Project	IEEE 802.16 Broadband Wireless Access Working Group http://ieee802.org/16 >		
Title	Procedures Clarifications and Improvement for MBS Logical Channel support in 802.16REV2		
Date Submitted	2008-04-20		
Source(s)		mailto:	
	Jonathan Segev, Comsys	jonathan.segev@comsysmobile.com	
	Tricci So, ZTE	tso@zteusa.com	
	Jerry Chow, ZTE	jchow@zteusa.com	
Re:	P802.16Rev2/D4, LB26c		
Abstract	The current definition of Logical Channel support for MBS has deficiencies in the areas of CS classification and CS SAP, and in the support for packing and robustness in the presence of MAC header detection errors for multi-PDU MBS bursts on the MAC data path.		
Purpose	Adoption toward REV2/D5		
Notice	This document does not represent the agreed views of the IEEE 802.16 Working Group or any of its subgroups. It represents only the views of the participants listed in the "Source(s)" field above. It is offered as a basis for discussion. It is not binding on the contributor(s), who reserve(s) the right to add, amend or withdraw material contained herein.

Procedures Clarifications and Improvement for MBS Logical Channel support in 802.16REV2

Proposed Modified Text to IEEE 802.16eRev2_D4:

Figure 10—Classification and CID mapping (BS to SS)

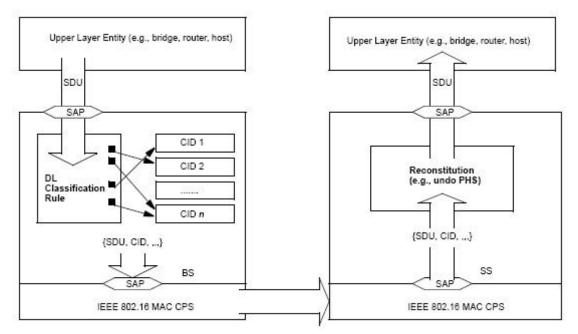
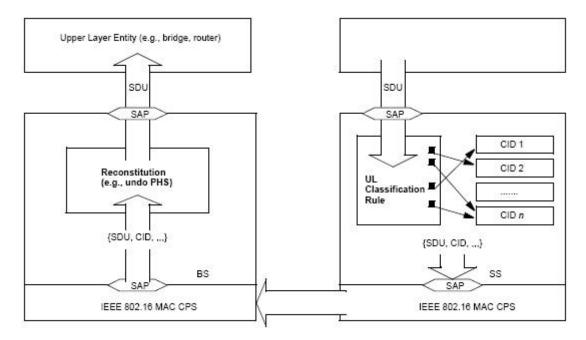
[Editor Note: Is there a need to add new figure for Classification to LCID mapping?]
